January 6, 2009

TEAM UPDATE #1

TEAM UPDATE #2

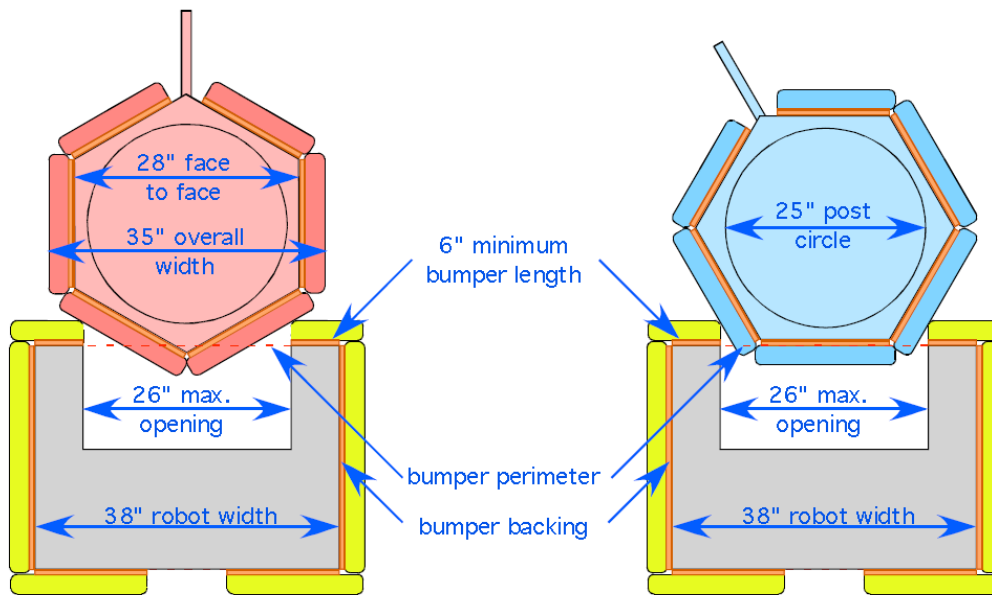
We would like to highlight an area in which we have received several questions. Teams are cautioned to consider ALL the factors associated with the construction of the required bumpers, and how those factors will impact the design of their robot. For example, individually these clauses of Rule <R08> can each impact the topology of the robot:

- “Each bumper segment must be at least six inches long” (Rule <R08-A>)
- “Each bumper segment must have plywood backing” (Rule <R08-C>)
- “Corners must be protected by bumpers” (Rule <R08-I>)
- “2/3 of the bumper perimeter must be protected by bumpers” (<R08-K>)
- “No hard bumper parts past the bumper perimeter” (Rule <R08-O>)

But when taken together and the robot is designed to satisfy ALL of the requirements of the rule, these clauses can have a very pronounced effect. In the case of the archetype “wide drive” robot with a centered opening on the front of the robot, this can result in a significant limit on the size of the opening. This limits the ability for incursion inside the bumper perimeter by the trailer. See the example below.
